ROCKBRIDGE AREA CONSERVATION COUNCIL

June 6, 2016

Re; Rocky Forge Wind Energy Project

Map

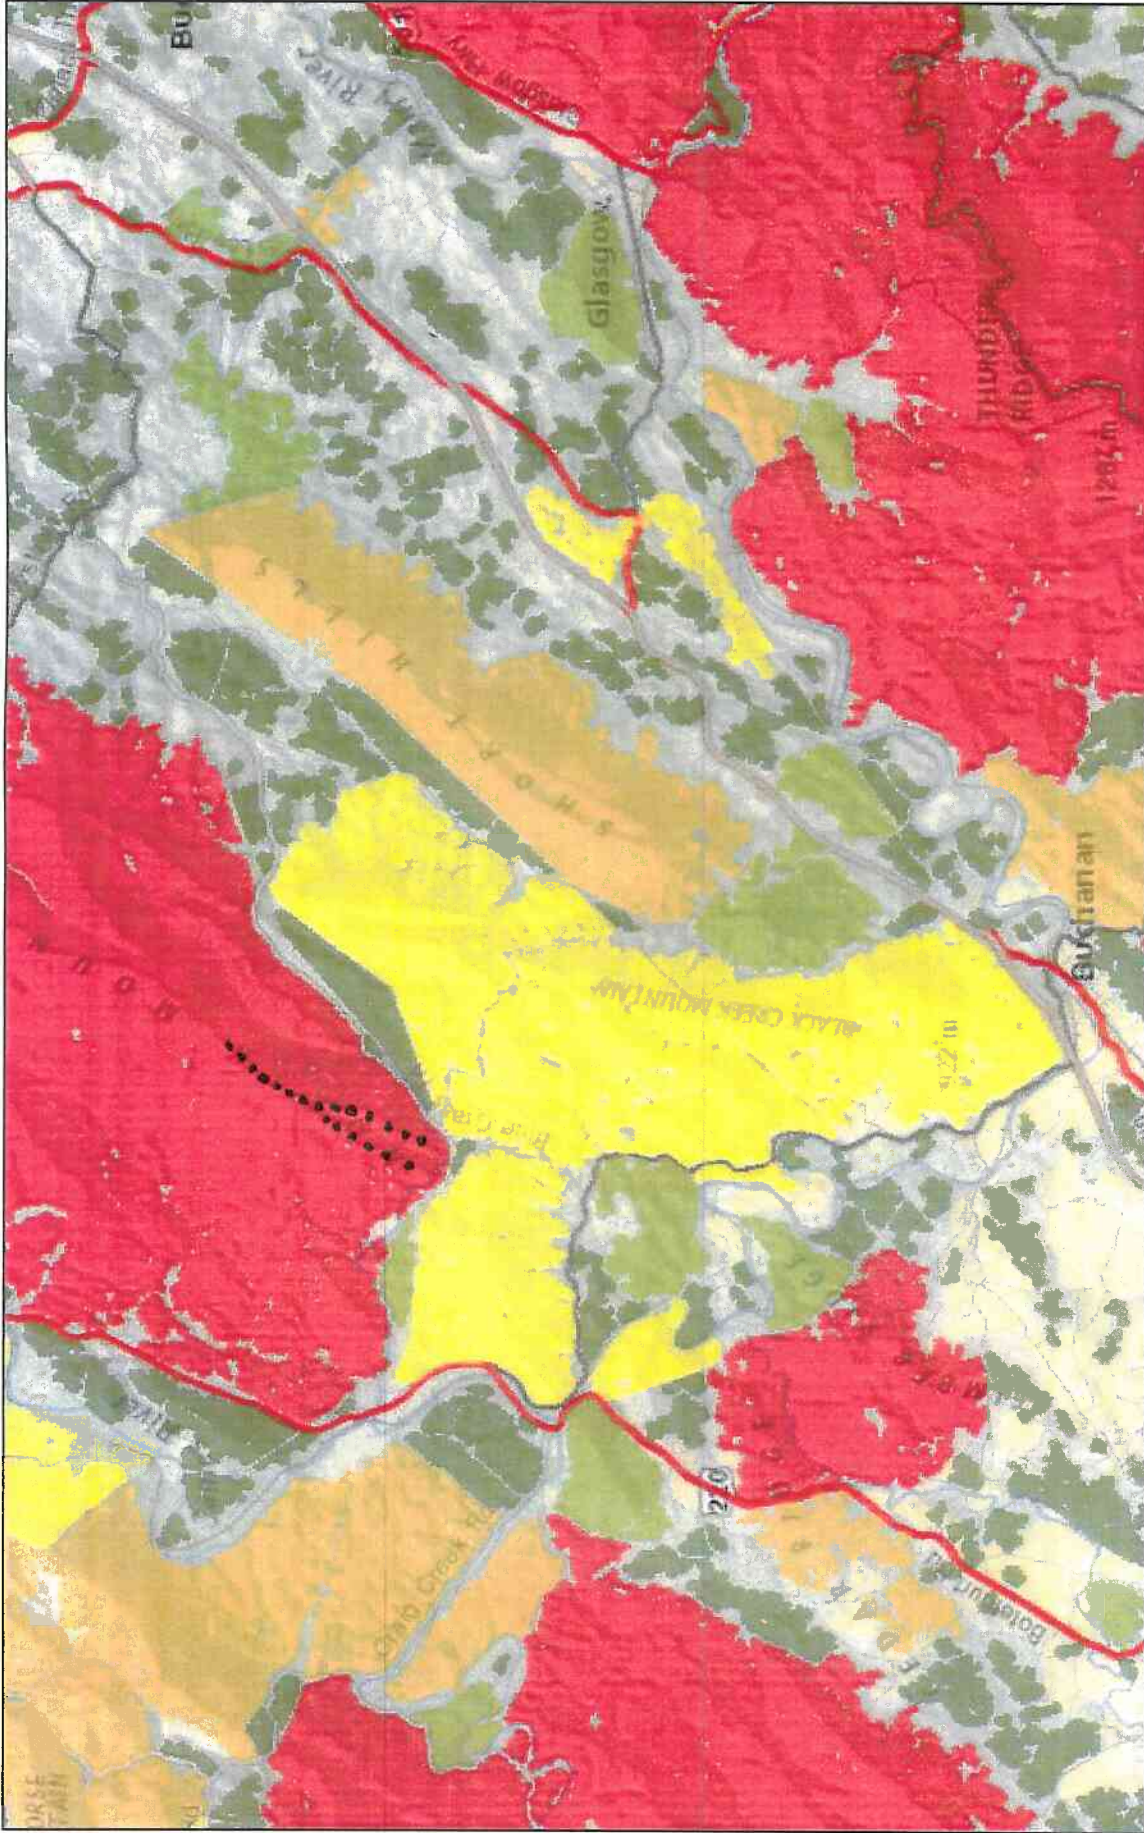
The entire RF Project Disturbance Area, Project Area and Buffer Zone are in an area with an Ecological Integrity Score of C1 – Outstanding. The adjacent core areas of Purgatory Mountain over to the Blue Ridge are also rated as Very High, High or Outstanding,

thereby providing the last functioning wildlife corridor across the I-81 urbanizing corridor (see VaNLA Map attached).

Attachment 7C (1) of the Rocky Forge Wind-PBR application does not fully address the DCR-VHNP's Ecological Integrity Score of C1. Without a careful regional assessment of the natural ecology impacts created by this proposed Project's development (along with the several others industrial wind turbine projects developing along western Virginia's forested mountain ridgelines), RACC contends that no offered mitigation plan or post construction monitoring for this Project may sufficiently or adequately offset the negative natural ecological impacts, either short term or long term, to the citizens, residents, or natural populations of Virginia and the upper James River watershed.
